Enclosure 3
Meeting Summary Handouts
of the January 19, 2012
ROP Public Meeting

NRC Staff White Paper on Performance Indicator Validity during Extended Shutdown and Start-Up Conditions

**Tentative NRC Response to
FAQ 11-12, FitzPatrick Downpowers**

Diagram 1: Low flow area with debris build-up behind Boot

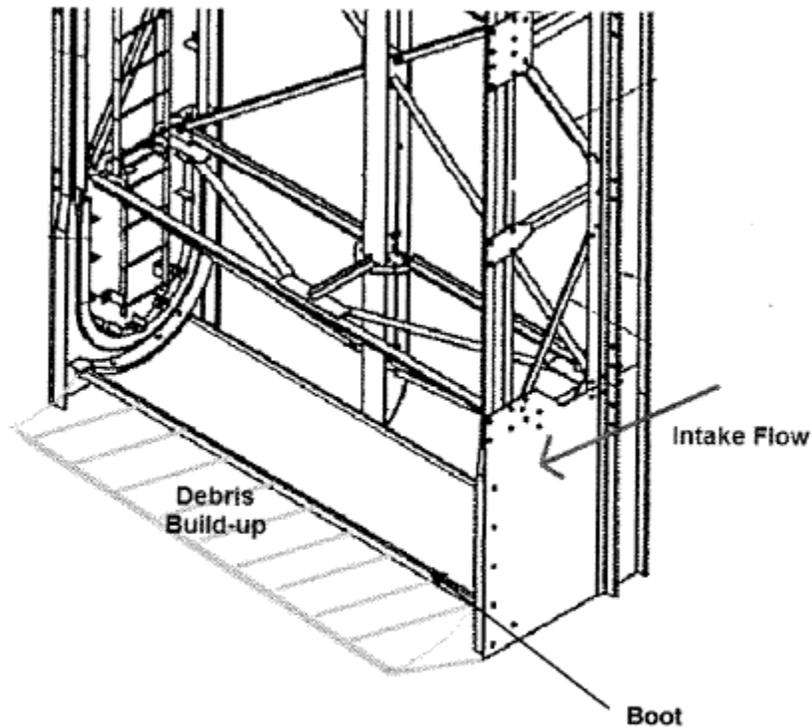
Based on the need to downpower the unit JAF performed an apparent cause evaluation and determined that the fouling observed was from a previously unidentified source. Based on the design of the boot and the cement, it appears that a low flow area may be forming just past the

boot. There is a possibility for small debris such as silt, sand, and broken zebra mussel shells to settle in this area south of the screens (pump suction side). In this area, the silt may settle out past the boots and build up to a level to meet up with the process flow. This condition would only take a short period of time to build-up and then would remain in the condition until cleaning could remove the debris.

During normal operation, this debris build-up is not a significant threat to fouling because the debris is settled. However, this area becomes vulnerable when the gates are installed because of the change in flow patterns and increased velocity.

During the maintenance activities beginning on 6/6/2011, the south gate was inserted to provide protection for the divers. The installation of the gate caused an increase in flow, which apparently caused the settled debris in the vicinity of the gate to be picked up by localized turbulence, resulting in fouling of the condenser. The apparent cause evaluation postulated

Tentative NRC Response:

NEI 99-02, Rev. 6, page 14, beginning with line 36, states, "Intrusion events that can be anticipated as a part of a maintenance activity or as part of a predictable cyclic behavior would normally be counted, unless the downpower was planned 72 hours in advance or the event meets the guidance below."

Although the licensee may have been aware that condenser fouling during the maintenance or inspection activity could potentially cause a downpower, the licensee was not planning to downpower to conduct the maintenance/inspection. The licensee stated in the FAQ that it could not reasonably anticipate that the debris south of the travelling water screens would have been sufficient to cause the observed condenser fouling. This statement indicates that the licensee was not planning to downpower. Therefore, the staff considers the downpowers to be unplanned.
